EARLY DESIGN GUIDANCE #2 - 550 BROADWAY

5 5 0 | B r o a d w a y | S e a t t l e , W a s h i n g t o n

DPD Project No.: 3012198
July 20, 2011

MASSING OPTION 4

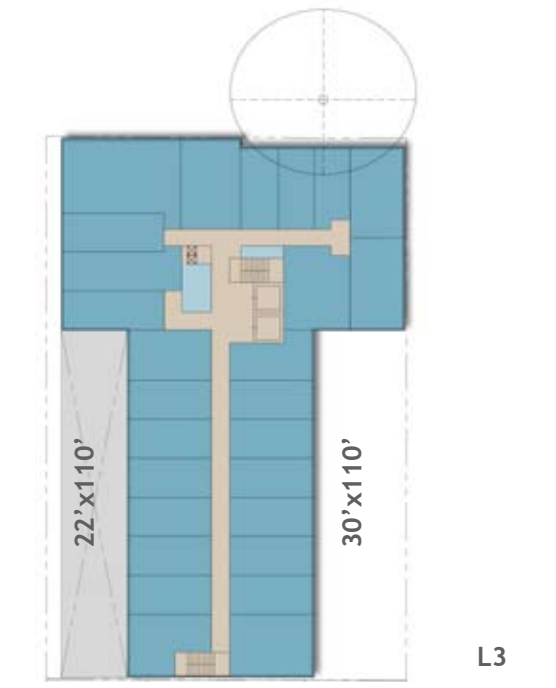
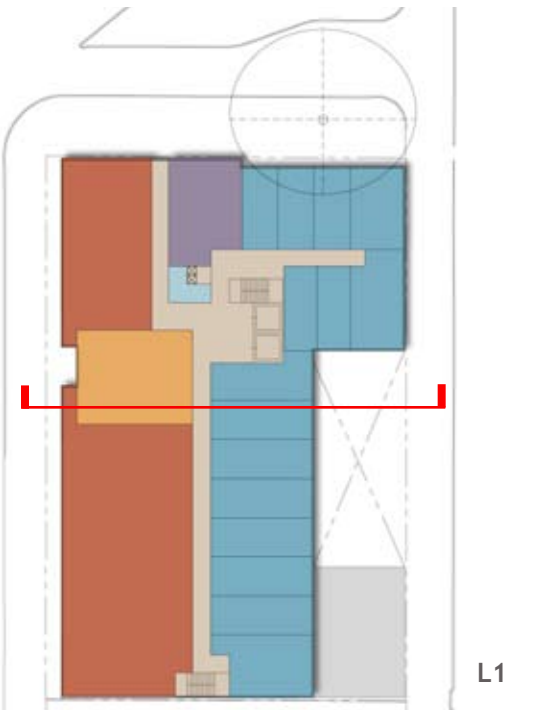
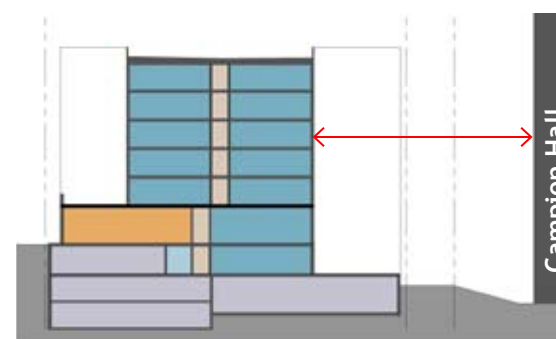
Shifting the courtyard to the Broadway side (The applicant should consider as another option.), the Board observed, would engage the residential entry and the commercial uses as well as provide more direct light. The Board encouraged the applicant to develop at least one other option as well. The open space needs to be viable amenity for any of the schemes.	Option 5 shows a scheme with the courtyard along Broadway. It is the applicant's concern that the courtyard along Broadway will be noisy, while providing less privacy and quiet as one that faces east. Further, this arrangement provides an excess of commercial space and a fewer number of apartment units. A larger number of units are against Campion Hall, reducing daylight.
A-8 Parking and Vehicle Access. Siting should minimize the impact of automobile parking and driveways on the pedestrian environment, adjacent properties, and pedestrian safety.	The Board agreed with the use of the alley for vehicular access.

CON: 200+ units desired

PRO: good light to both east and west facing units

CON: small courtyards limit communal gathering space

PRO: less units facing south light well

SHADOW STUDIES FOR PREFERRED SCHEME

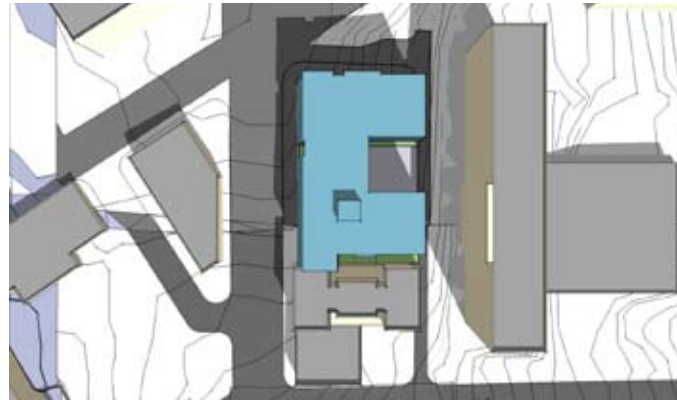
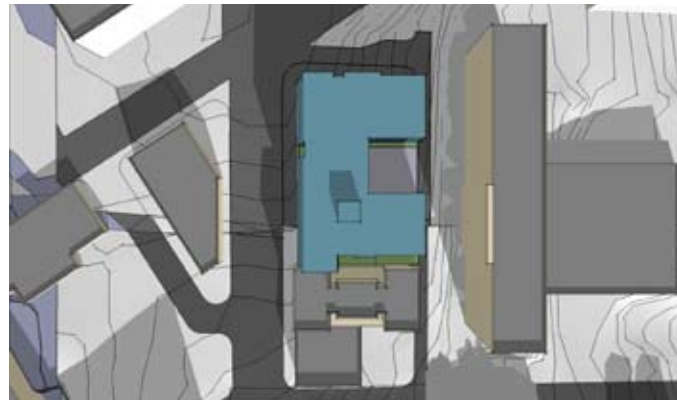
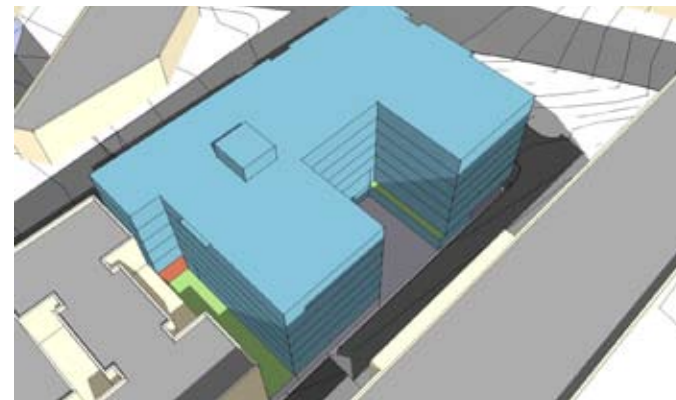
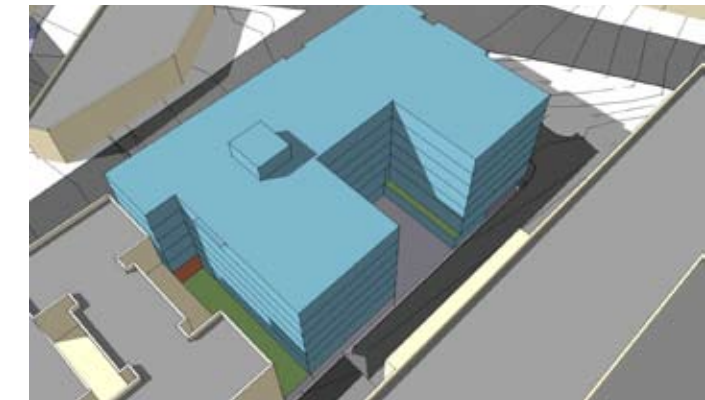
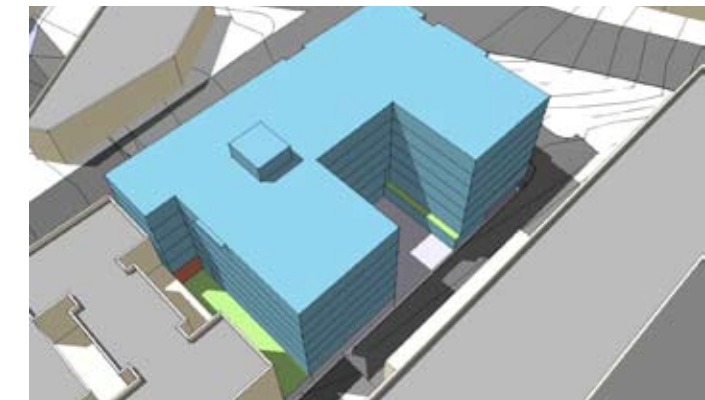
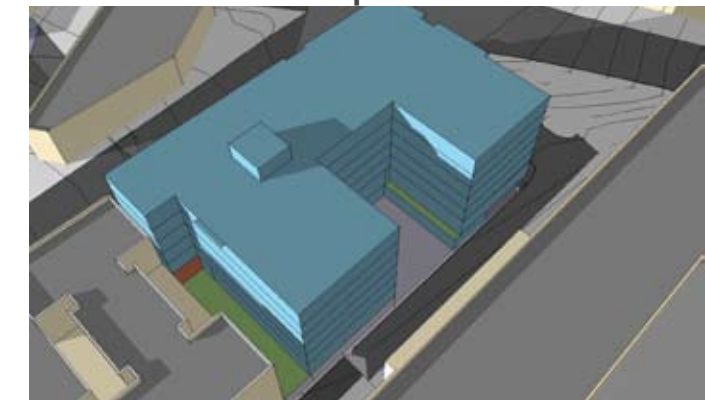
A-7 Residential Open Space. Residential projects should be sited to maximize opportunities for creating usable, attractive, well-integrated open space.	The Board finds the courtyard for Option #3 problematic. The benefits to the residents appear questionable as sunlight would never penetrate into the court (see shadow studies p. 19 of booklet). The court would sit at alley grade rather than at the level of Broadway and extend 70 feet to the roof. Only four units and an amenity space would have direct access to it. For Option # 3, the Board encouraged the applicant to enlarge the space and extend the width in an attempt to capture more light.	Option 3 has been improved and is now Option 6. The courtyard has been enlarged to provide more access to light. Although the shadow studies found on page 19 (EDG #1) did not show light penetrating the courtyard, in the afternoon and evening light will reach the south facing units. See shadow studies on page 11.

DESIGN GUIDELINE	RECOMMENDATION	RESPONSE
D-1 Pedestrian Open Spaces and Entrances. Convenient and attractive access to the building's entry should be provided. To ensure comfort and security, paths and entry areas should be sufficiently lighted and entry areas should be protected from the weather. Opportunities for creating lively, pedestrian-oriented open space should be considered.	Board comments focused on the courtyard and the potential for open space and entrances along E. James. In option # 3, the courtyard appeared to a leftover or minor space. Without penetration of sunlight in the courtyard, the Board doubts the viability of a courtyard facing Campion Hall. Possibilities include raising the courtyard, changing the size and dimensions and moving it to another location. The Board wondered why option #1 wasn't viable at seven stories (one floor less than shown) as it would have roughly the same number of units as option #3. Future drawings of the courtyard and other significant open spaces should read as three dimensional spaces.	See A-5. It is the applicants view that the courtyard location provides a quieter setting off the treed lane that joins this site with the Seattle University campus. Sheet 11 demonstrates that sunlight does in fact penetrate the courtyard.
